Our ref: 20-0143P

RE: Response to Further Advice

Reconfiguring a Lot (ROL) for two (2) into sixteen (16) residential lots, a balance lot and a partial lot
480 and 500 Rochedale Rd, Rochedale, QLD 4123

Figure 1: Swept Path Assessment (In Relation to RCV Manoeuvring and Temporary Speed Platform Location)

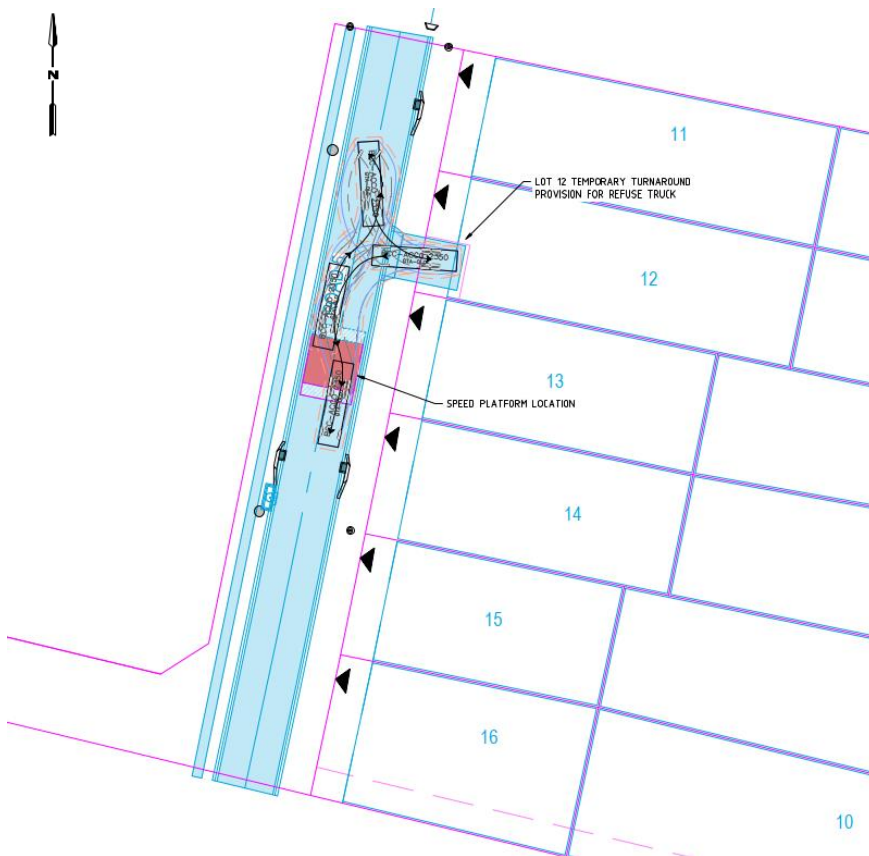
The location of the speed platform conflicts with a future road anticipated over 470 Rochedale Road. The speed platform is not considered to be suitable within a T junction and would need to be removed with development of 470 Rochedale Road (likely replaced with a modified T intersection). Requiring the Refuse collection vehicle (RCV) to manoeuvre over the speed platform on the turn out of the temporary turning area as shown in the swept path diagram is also undesirable.

Installing the speed platform at the frontage of proposed Lot 15 would remove the device from the future T intersection. Relocating the device further north is not supported as it would impact on the RCV interim turning area.

- a) Provide amended plans to show the proposed speed platform located on the frontage of Lot 15.

To respond to Council's concerns for manoeuvring around the temporary speed platform, an RCV will not need to traverse this platform immediately in exiting the temporary turning area. As demonstrated by Figure 1 below, manoeuvring in and out of the RCV temporary turning area can occur clear of the platform. Nonetheless, we acknowledge that some switch-back will be required for the egressing RCV towards the platform. Most importantly, the implications of this arrangement are minor and temporary, and we note that the RCV would need to traverse the platform in each direction to service the northernmost lots in any case.

We maintain that the location of the temporary speed platform to the frontage Lot 13 is appropriate and that there would be limited practical benefit in relocating the temporary platform to the frontage of Lot 15. Since the speed platform is intended to be temporary, the platform does not need to be positioned away from the T intersection which will remove/replace it.
